Three Mile Island Nuclear Station, Unit 2 (TMI-2)  
License No. DPR-73  
Docket No. 50-320  
Reactor Containment Building Atmosphere Cleanup

Enclosed are the responses to the 33 questions raised in your letter of December 18, 1979. If you need further explanation of these responses to complete your Environmental Assessment, please contact Mr. Ed Fuller at (201) 263-6331. We would be pleased to meet with you to discuss our responses if that would expedite the NRC review and approval of our requests to proceed with purging the TMI-2 Reactor Building.

# HP-R-227 REACTOR BUILDING

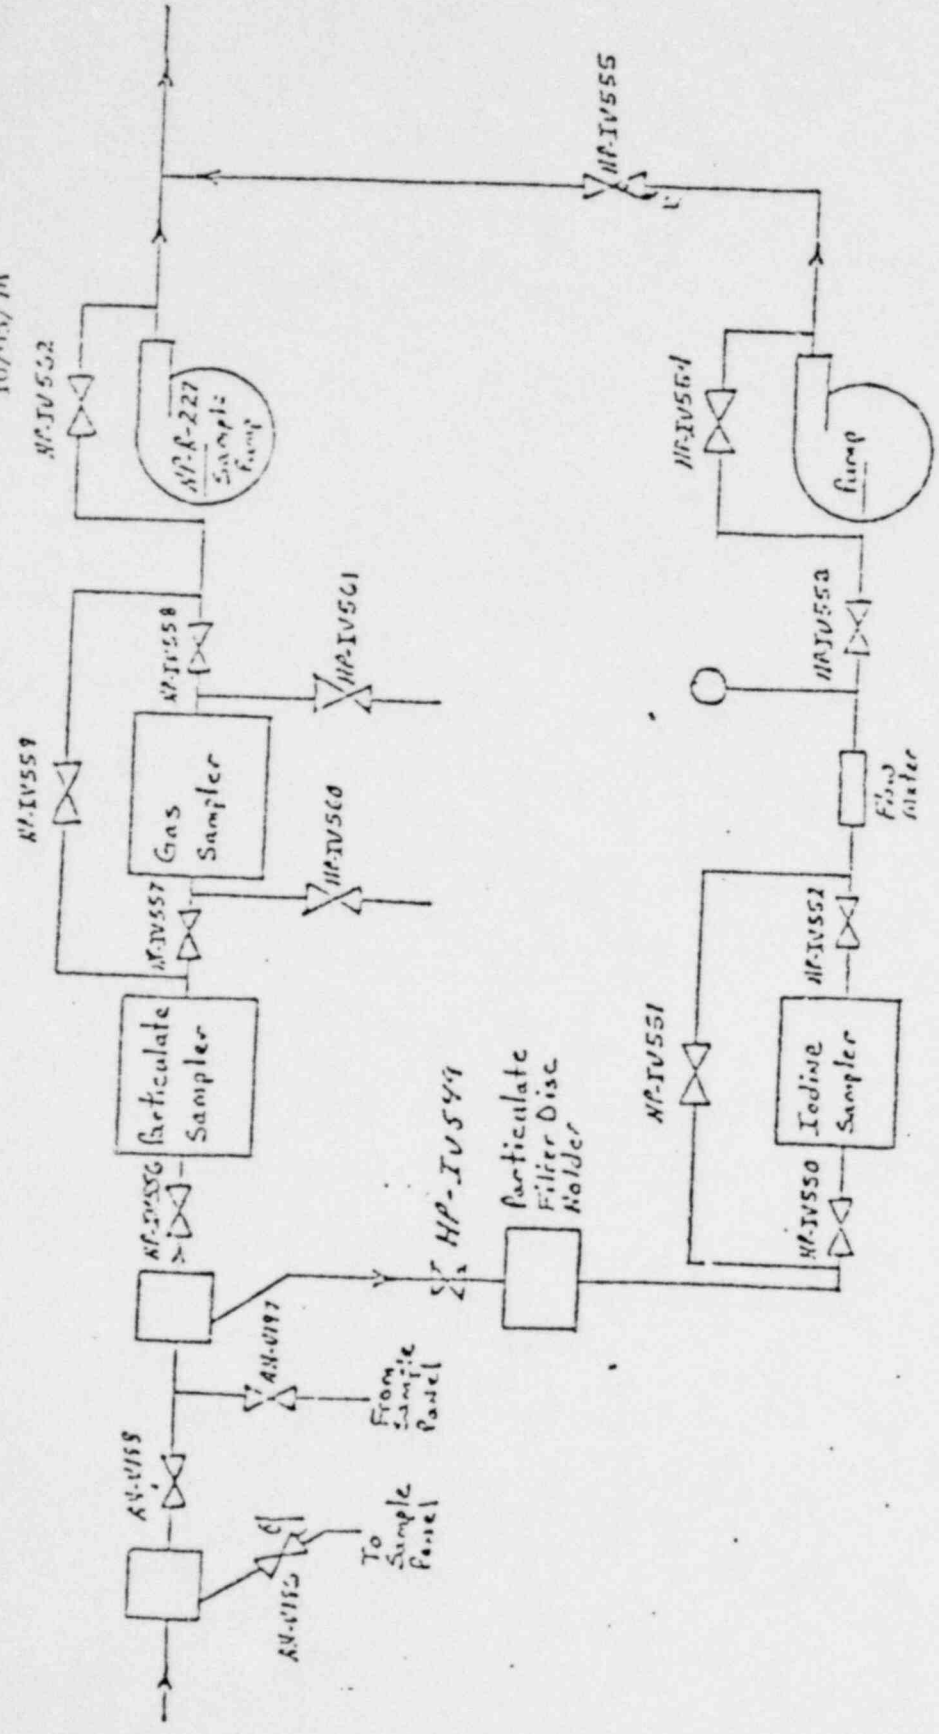
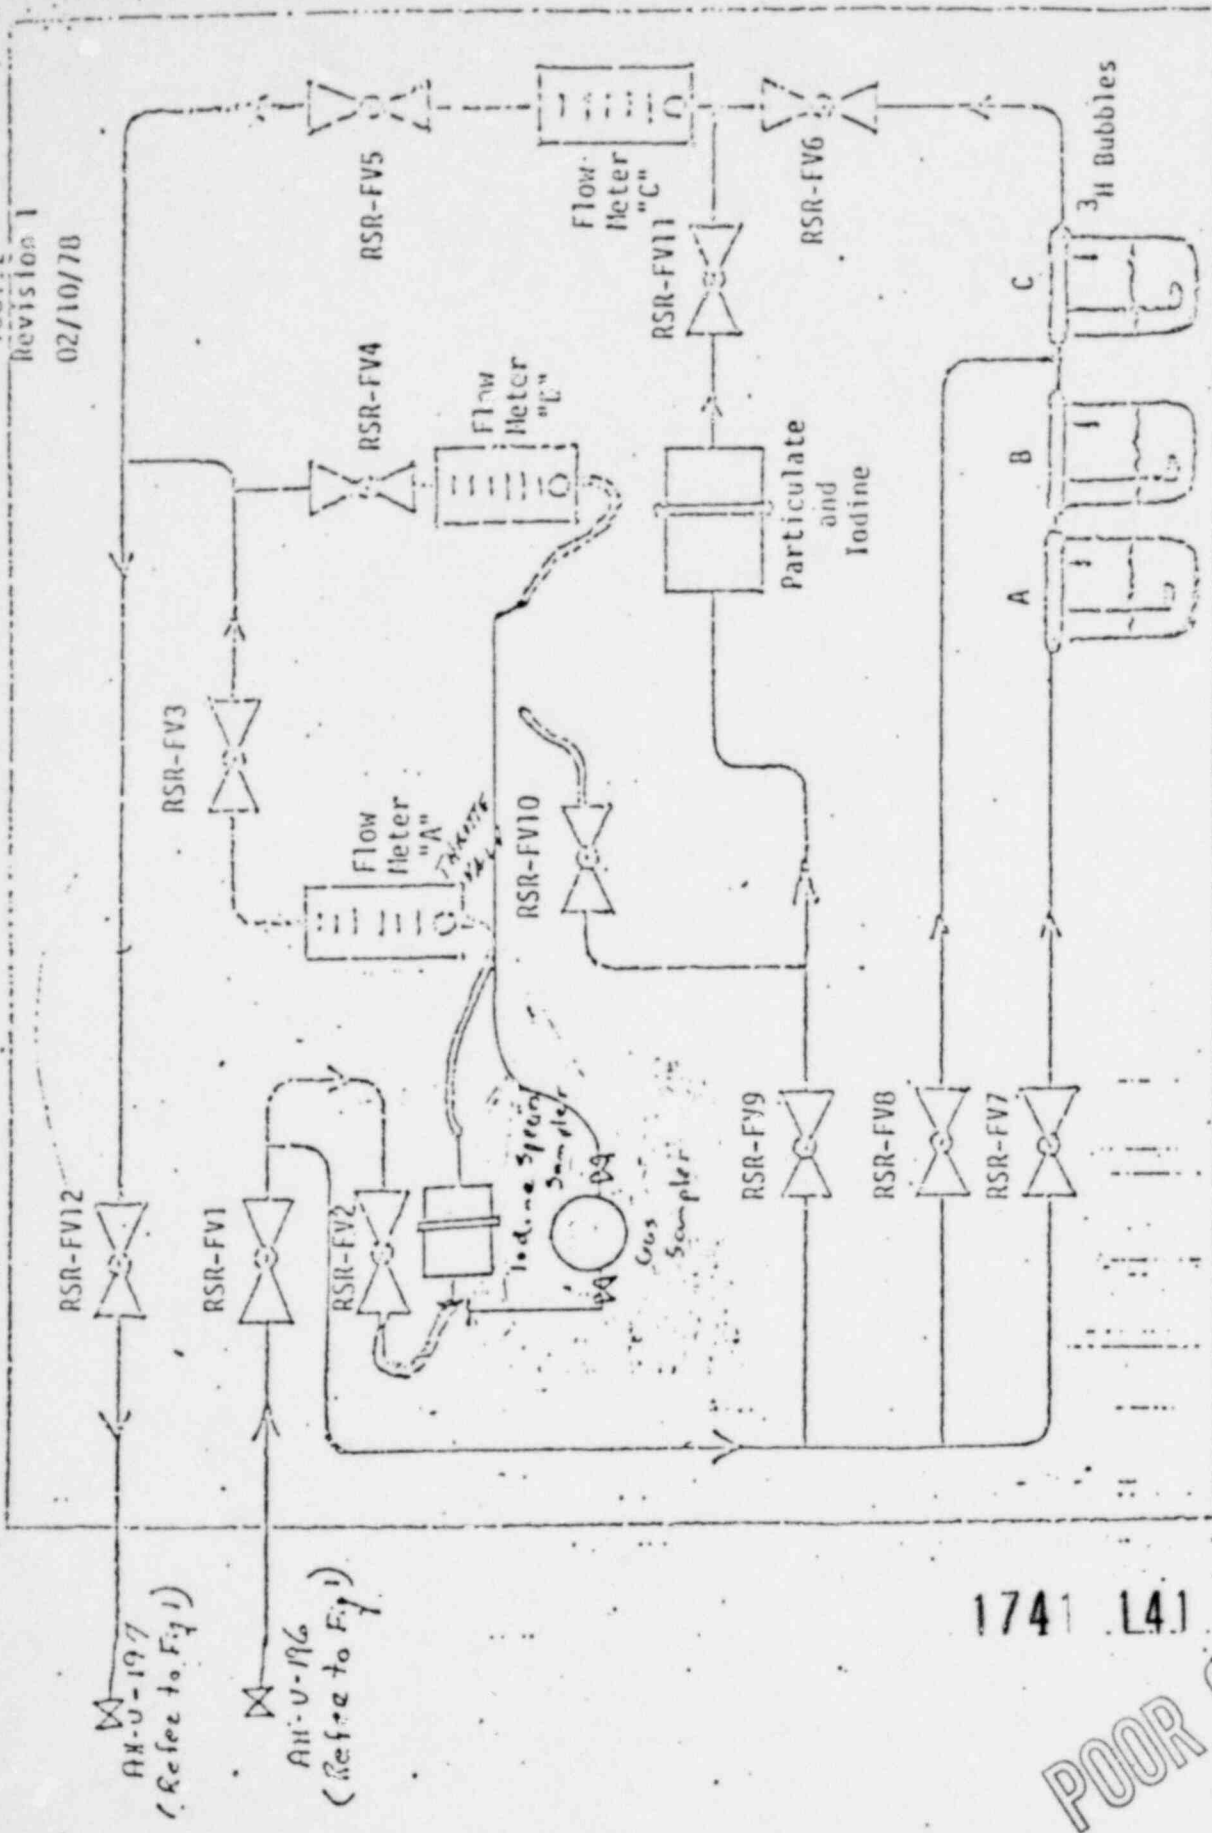
14. Page 15, Section 3.3.3., First Paragraph.

Provide a description of the radiation monitor.

HP-R-227 is a sample panel, not a radiation monitor, which allows direct sampling of the reactor building atmosphere. The sample panel can be used to fill a sample bomb for gas analysis, to perform a particulate analysis by drawing containment air through a filter, or to perform a tritium analysis by using the installed bubbler. The attached system sketches provide details of the sample system.

FIGURE 10. CALCULATED VERSUS EXPERIMENTAL BREAKTHROUGH CURVES

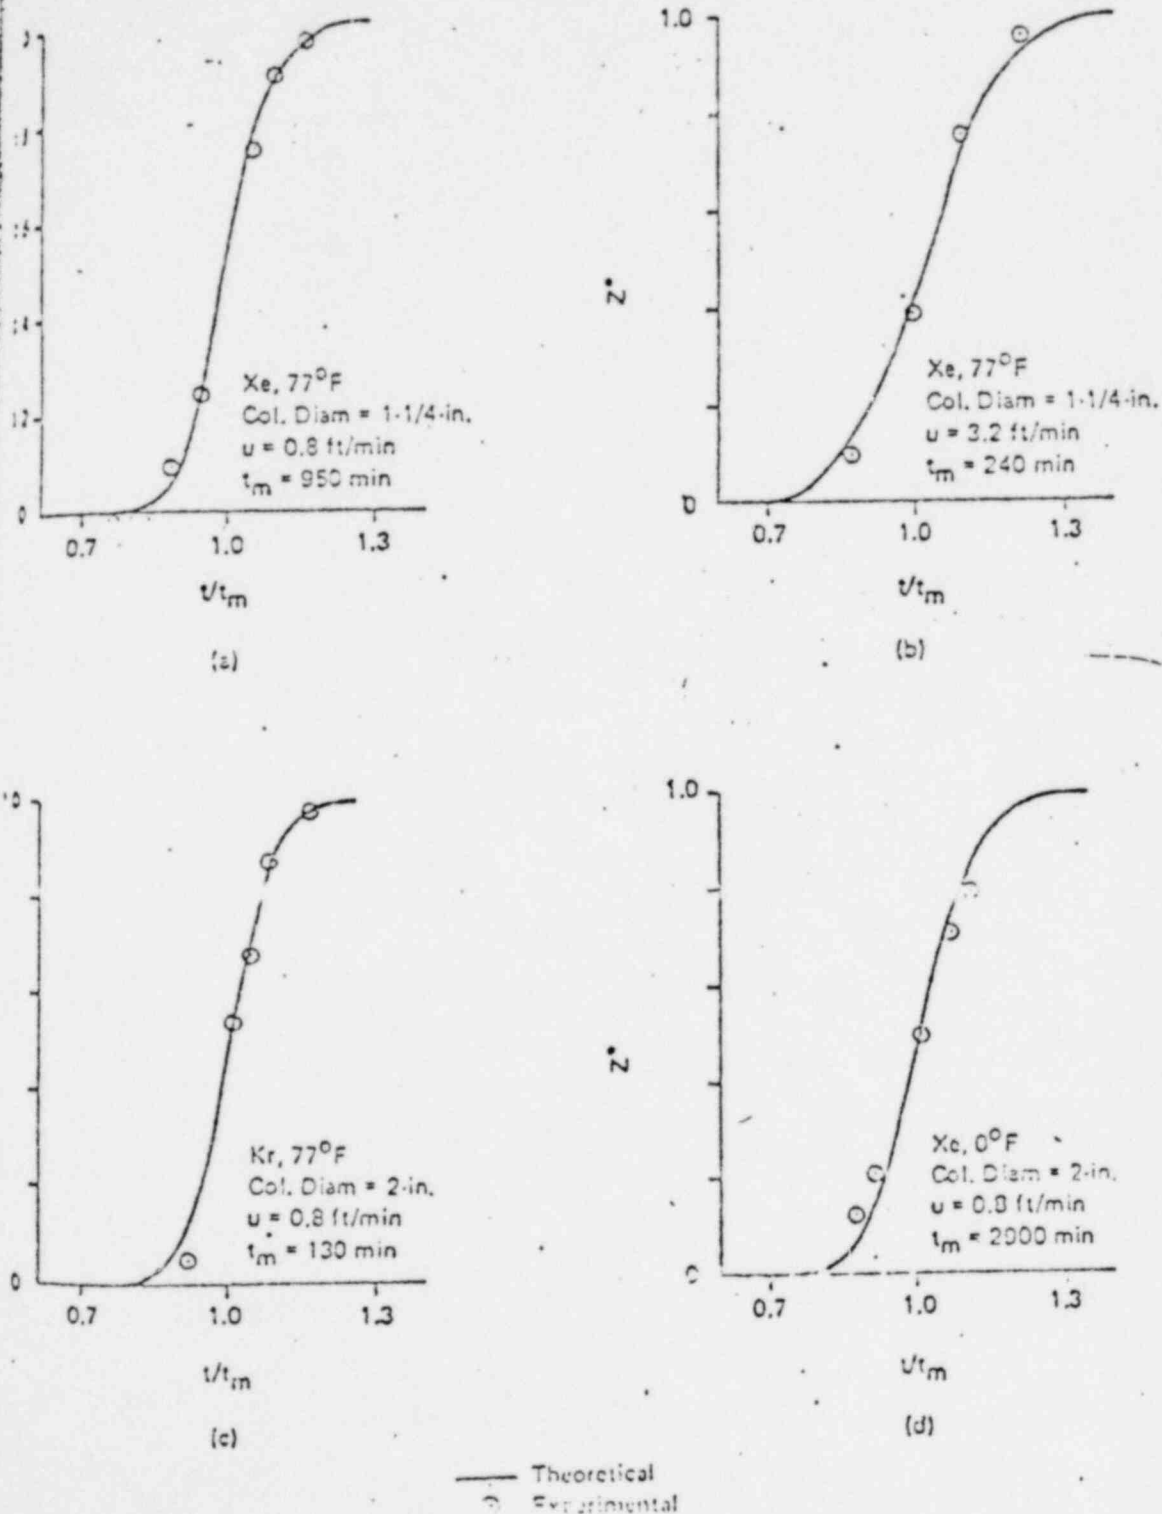
29. Page 71, Section 8.3.1, System Description.

Provide the basis for the 34,000 tons of charcoal stated in this section. Provide justification as to why it is necessary to design and construct the tanks to Section III, Class 3.

From Figure 10 of NEDO-12327, the time to "break-through,"  $t_b$ , is on the order of  $0.7 t_m$ .

Using a minimal amount of conservatism, let  $t_b = 0.65 t_m$ :

PRELIMINARY SCHEDULE

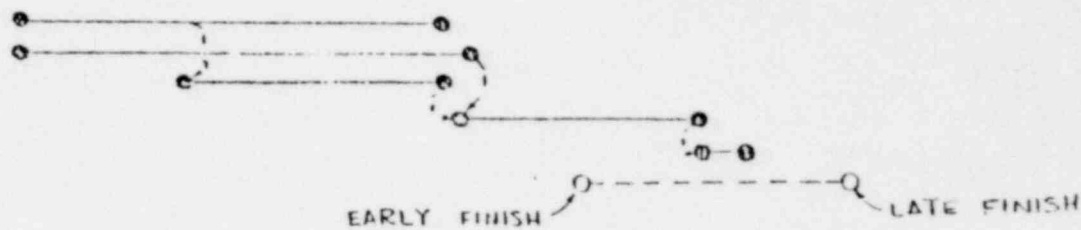
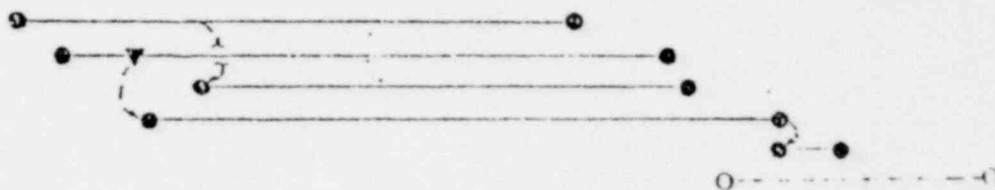
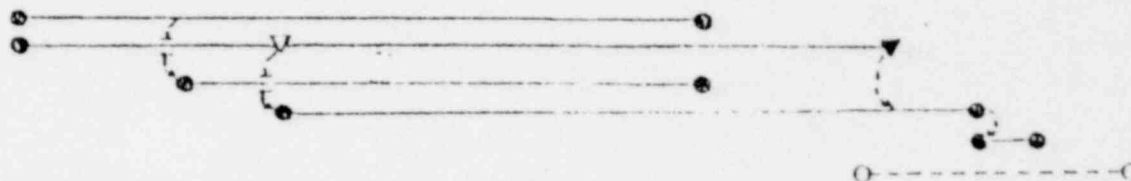
30. Page 73, Section 8.3.3, Cost and Schedule Estimate.

Provide a detail breakdown to justify why it will take 30 to 40 months to design and construct this system.

In order to evaluate the effort required to place the alternate systems into operation, Metropolitan Edison performed a scoping evaluation which included a preliminary system design for each alternate. These preliminary systems were then evaluated by Metropolitan Edison's architect engineer to determine schedule and costs for implementing the systems. The schedule determined is as shown in the attached bar chart. Our architect engineer used standard industry estimating and scheduling techniques to determine the times and costs presented. The cost and schedule estimates are based on years of experience and considered judgement and are considered adequate for use by Metropolitan Edison. A more detailed estimate would require greater design detail, which would impose additional, unwarranted delays in solving the Krypton-85 problem.

In order to complete the cost and schedule estimates, the architect engineer assumed as a base (or most probable) case that the buildings, equipment, piping, supports, and electrical service were seismic Category I and that the piping design code was ASME Section III, Division I, Class 3. The reasons for these assumptions are presented in the answer to Question 25. Additionally, shortest schedule/least cost and longest schedule/maximum cost estimates were also made. For the shortest schedule evaluation, buildings, equipment, piping, supports, and electrical service were non-seismic, and the piping design code was ANSI B-31.1/ASME VIII. For the longest schedule evaluation, the same seismic and code requirements as used for the most probable case were used, but aircraft hardening for the building was also assumed. In each case, the schedules and costs are considered to be the additional time/cost required for the alternates as compared to the base case of performing a controlled vent of the containment.
